# **ADDENDUM TO THE SUB-SLAB VAPOR PROBE INSTALLATION AND ADDITIONAL SITE ASSESSMENT WORKPLAN**

**1137-1167 65<sup>th</sup> STREET  
OAKLAND, CALIFORNIA**

**AGENCY CASE NO.      RO0000082**

**SEPTEMBER 30, 2010  
REF. NO. 521000 (10)**  
This report is printed on recycled paper.

FIGURE 3            UTILITY CONDUITS AND REVISED PROPOSED SUB-SLAB  
                             VAPOR PROBE LOCATIONS

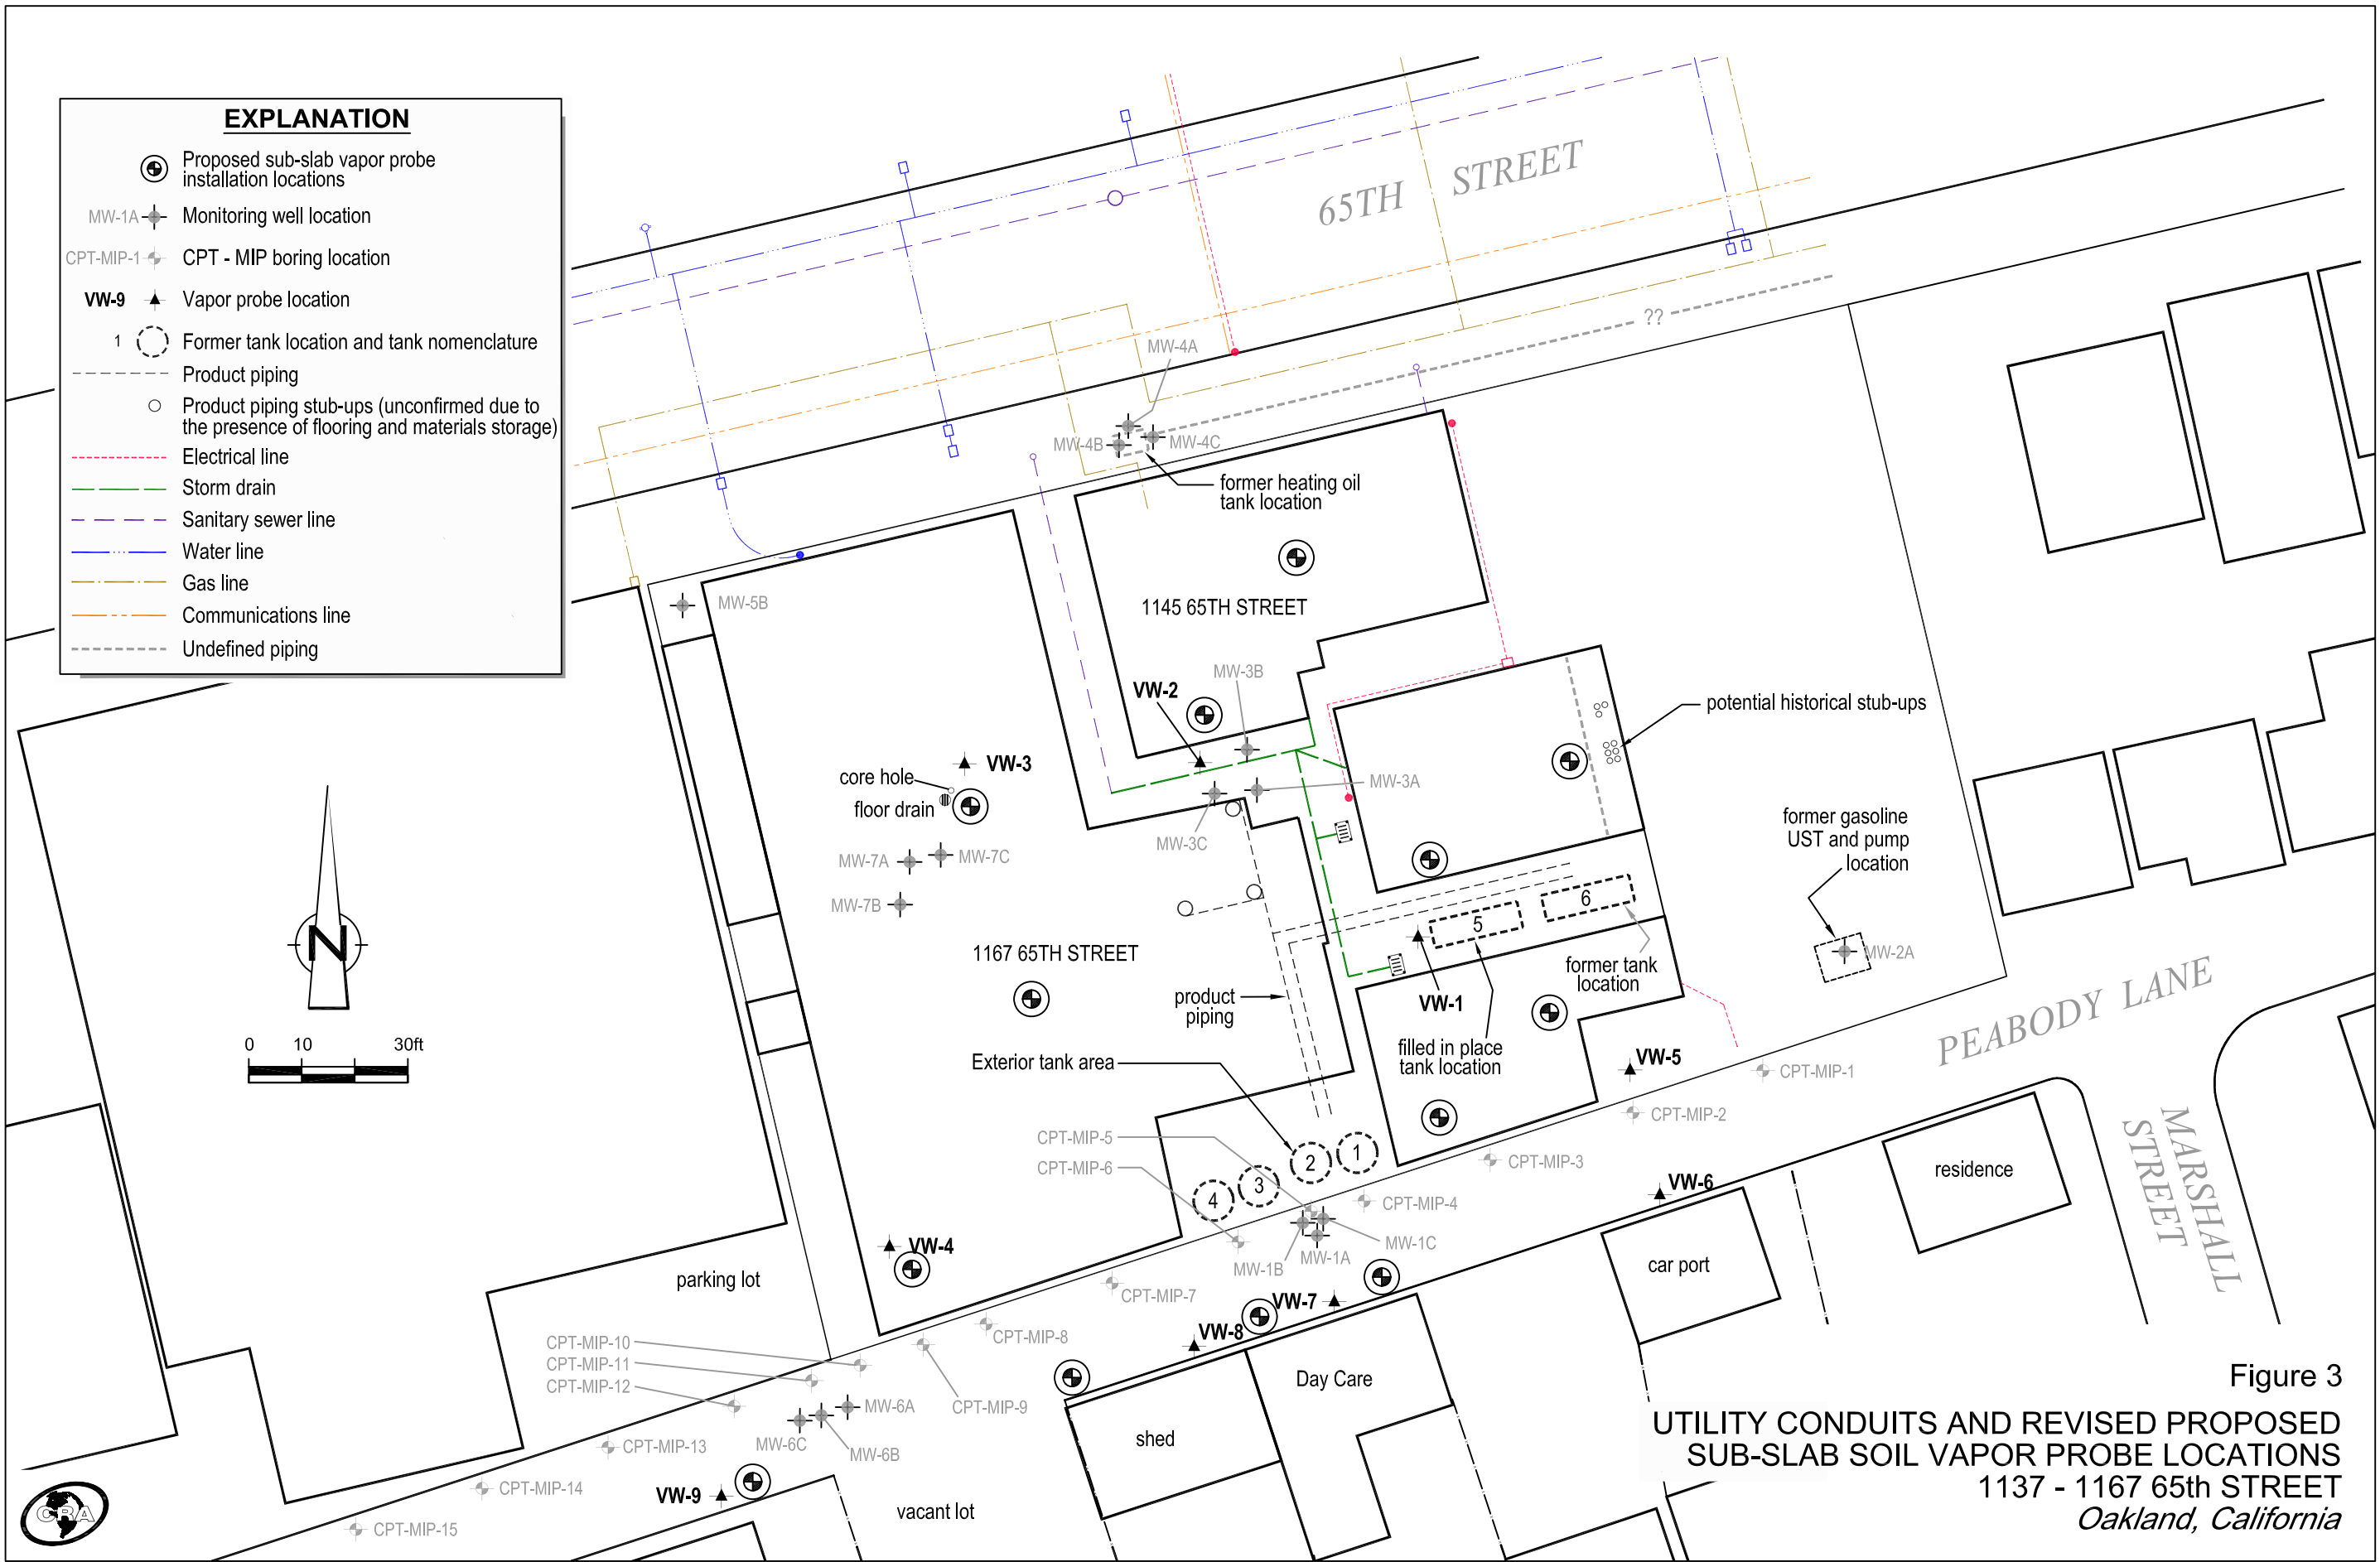
This comment pertains to a consideration of utility conduits in regards to proposed locations of subslab vapor probes within the onsite buildings, and specifically references the proposed location of a subslab vapor probe adjacent to the floor drain in 1167 65<sup>th</sup> Street. This location selected because the September 2009 and December 2009 vapor concentrations in VW-3, collected from 4 to 5 feet below grade (fbg), were among the highest reported from the nine vapor probes beneath and adjacent to the site. Other proposed subslab vapor probe locations were based on reported concentrations from the eight additional probes installed in August 2009. The valid concern of potential preferential migration along conduit trenches exists and the original Figure 3 identified only one utility conduit within the buildings. The only utility conduit beneath a building foundation shown on the original figure is that of subsurface piping from the former USTs (along Peabody Lane) to the interior USTs and to stub-ups within 1167 65<sup>th</sup> Street. To identify additional utility conduits, CRA contracted a private utility location service to perform a comprehensive survey. The utility conduit study occurred

1. **Sub-Slab Vapor Sampling Locations** – CRA proposed installing one on-site sub-slab vapor point inside the building immediately adjacent to a floor drain. However, utility conduits are not depicted on the map. Since there is a potential for contaminant vapor migration along preferential pathways (i.e. existing utility corridors) that are present at the site and in the street, we request that the locations of all conduits be depicted on the map and the soil vapor sampling points located accordingly. Please submit a conduit study with the work plan addendum by the due date requested below.

on September 9 and the results are presented below. Based on the findings of this conduit study, a revised Figure 3 is included with this addendum.

Based on results of the conduit study conducted September 9, only one subslab vapor probe location was modified. This change is a result of identified piping along the eastern interior wall of the building in, essentially, the center of the property. This new location, along with the identified piping is shown on the revised Figure 3.
